Planning for Success.

Re: Ramsay Park Renaissance Project Initial Study/Mitigated Negative Declaration (IS/MND) Evaluation of Changes to the Project Description

Existing Conditions of Longview Drive Parcel

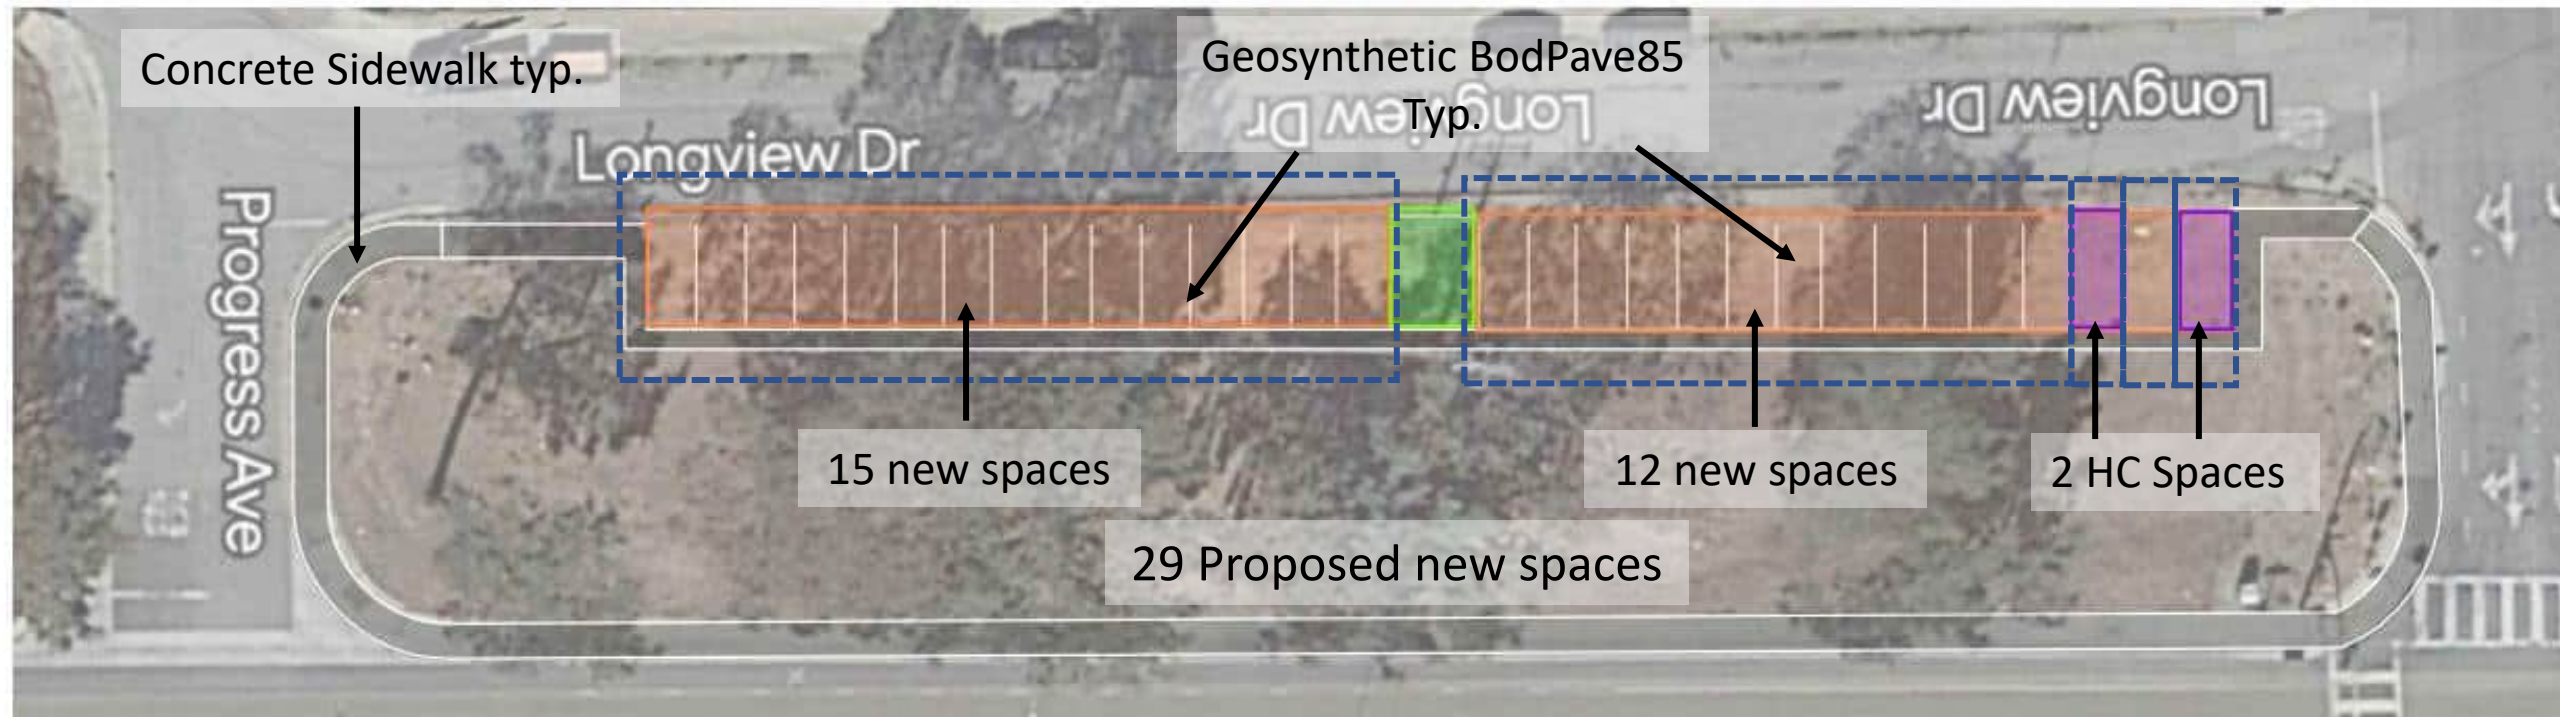
Existing Conditions at Proposed Location

Existing Conditions at proposed Longview parking lot location

Proposed Longview overflow parking lot

Original location of overflow parking lot

The intent is to provide overflow parking for Ramsay Park at the Longview Drive parcel, to replace the previously proposed new parking lot on Main Street at the park. The Longview Drive parcel is currently a 375-foot long by 80-foot wide vacant, curbed grassy median area with ten (10) blue gum eucalyptus trees and a Pacific Gas & Electric power line running through the approximate middle of the site. An existing conditions illustrative plan of the Longview Drive parcel is included as [Attachment B](#). An illustrative site plan for the Longview Drive parking area, is included as an [Attachment C](#). In addition, the following improvements and project features will be added or amended from the original project description:
